Addendum 3
Solicitation 23-AA07
Duluth Coastal Infrastructure Rehabilitation Project

Re: Duluth Coastal Infrastructure Rehabilitation – Addendum #3

AMI Project # 211016

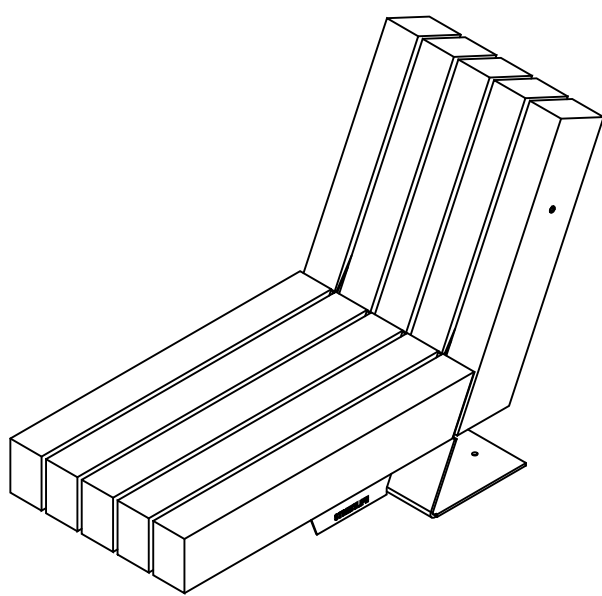
Please verify if the hanging hardware size is 1-1/2" Stud Link Chain and Shackles and the Chain Length?

Contractor is responsible for the design of the fender bracket connection and chain size, lengths & angles. Contractor shall also verify if steel panel dimensions (height & width) given in the plan set are adequate based on Contractor selected chains. Fender attachments shall be submit to engineer for review & approval.

SHEET:
E111

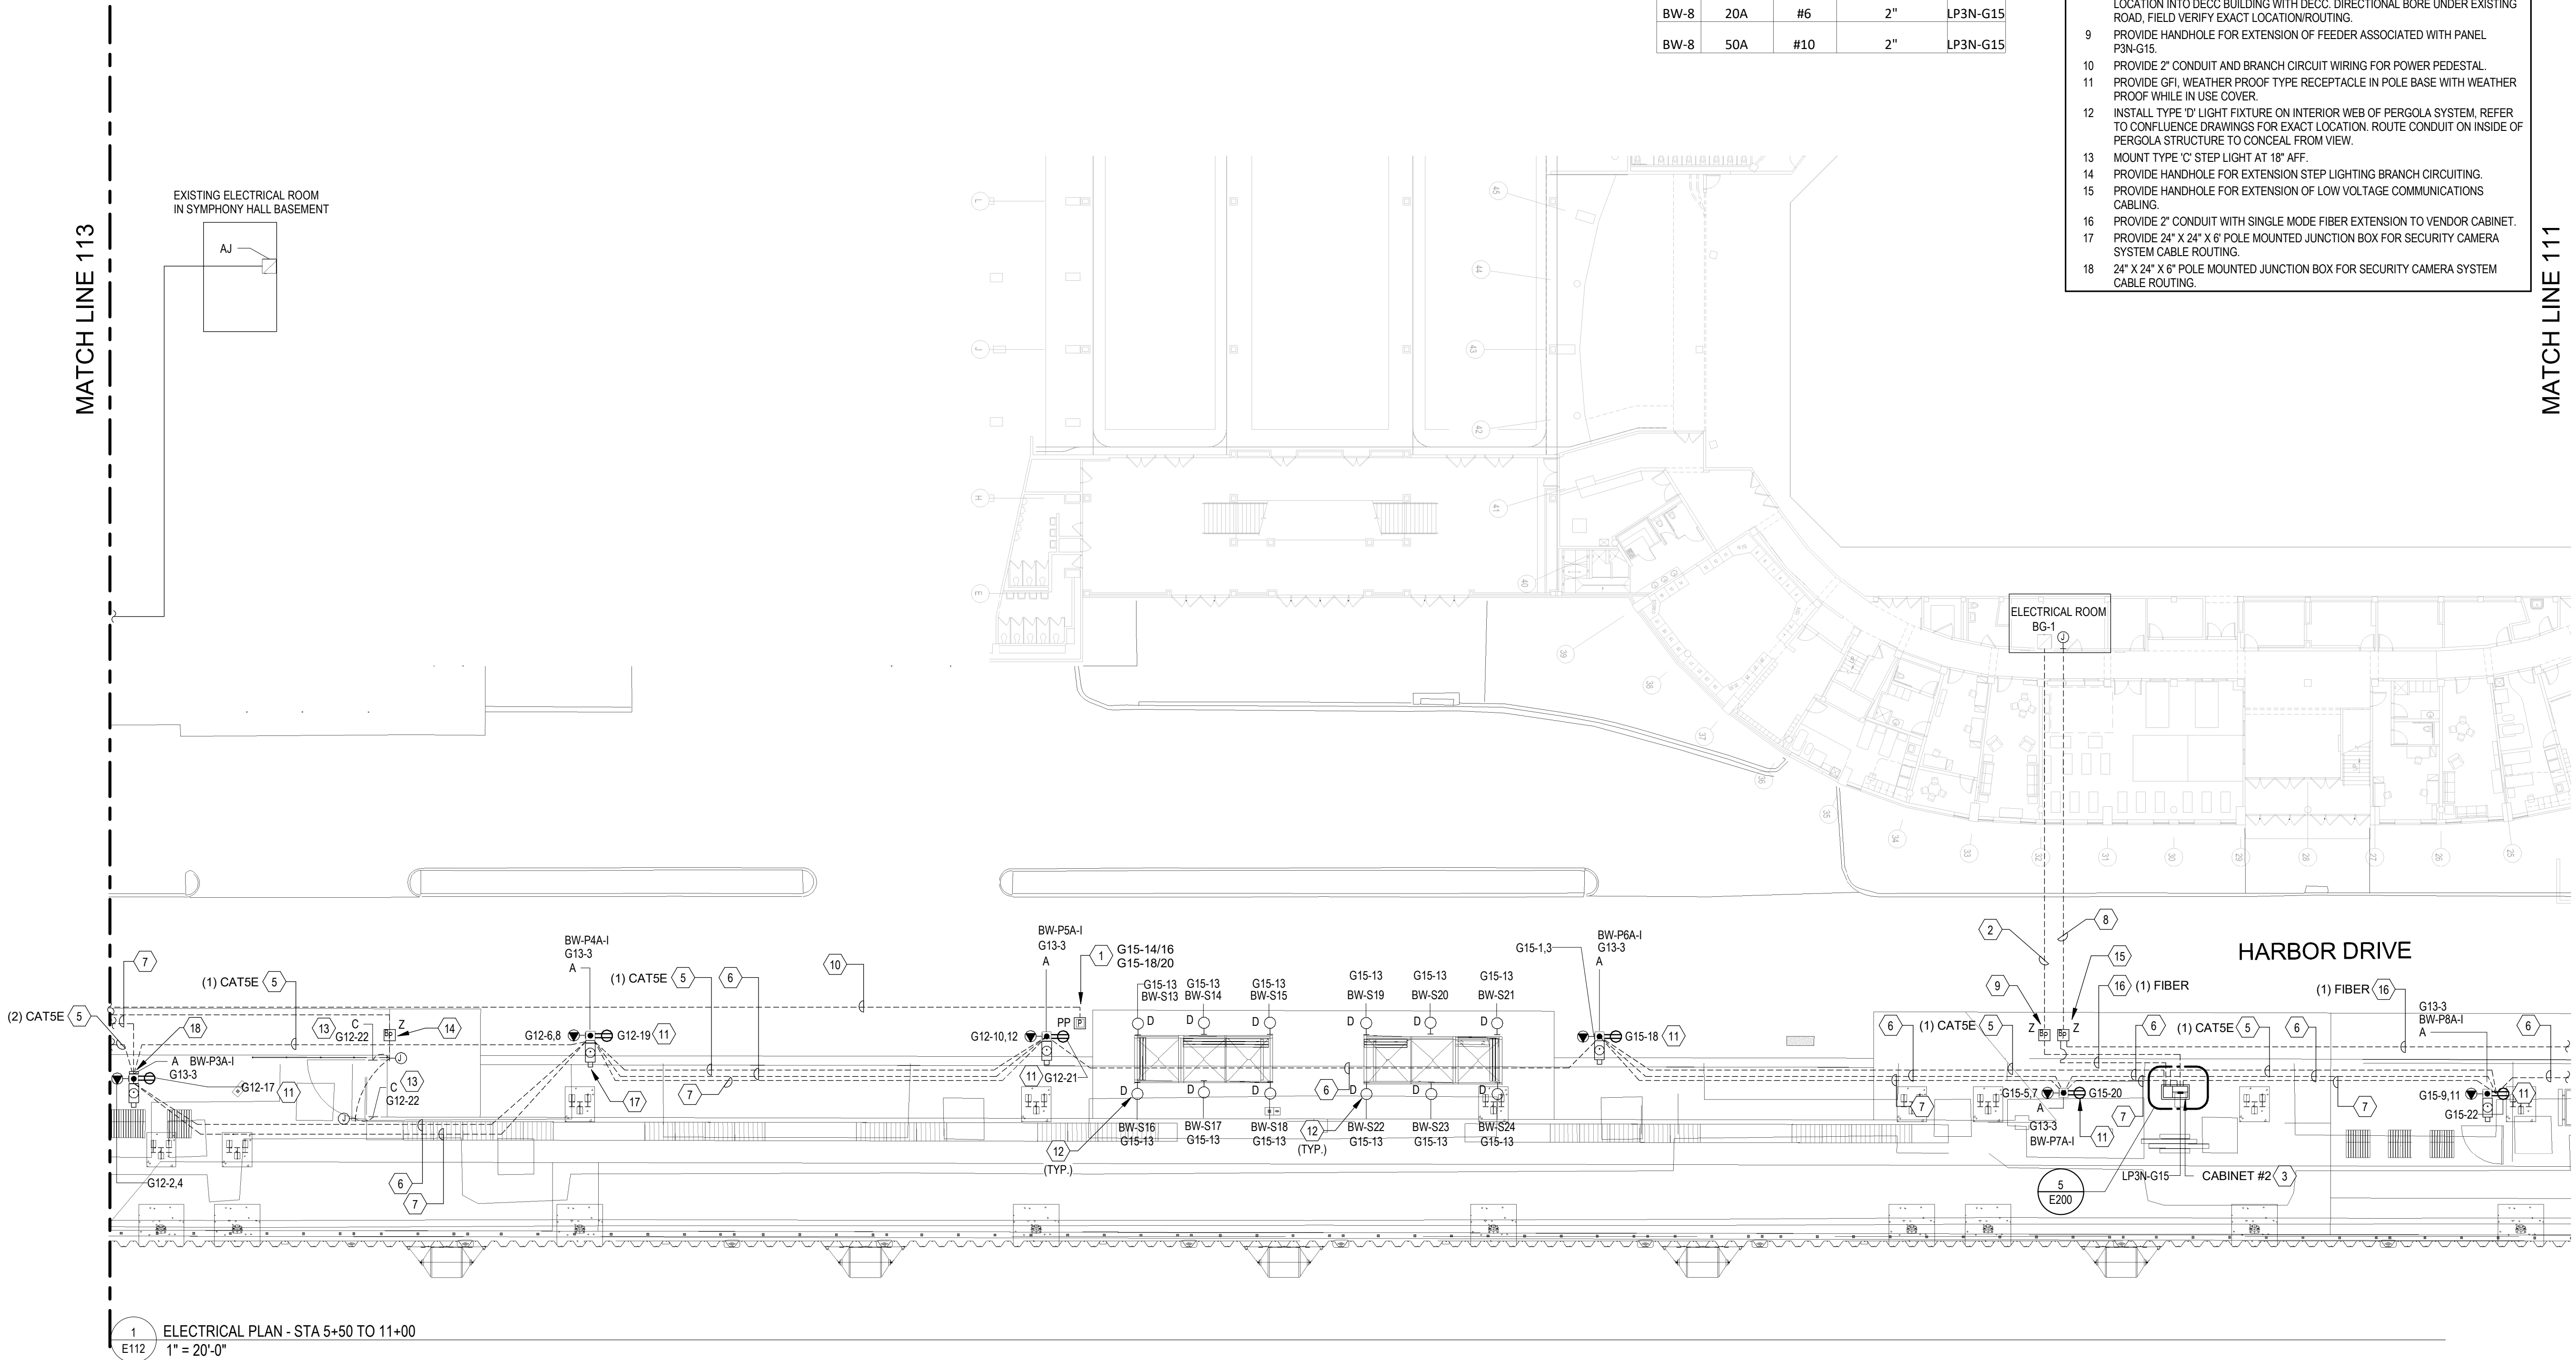
Ayres has updated sheet E111 and revised the electrical specifications. They are attached to this addendum.
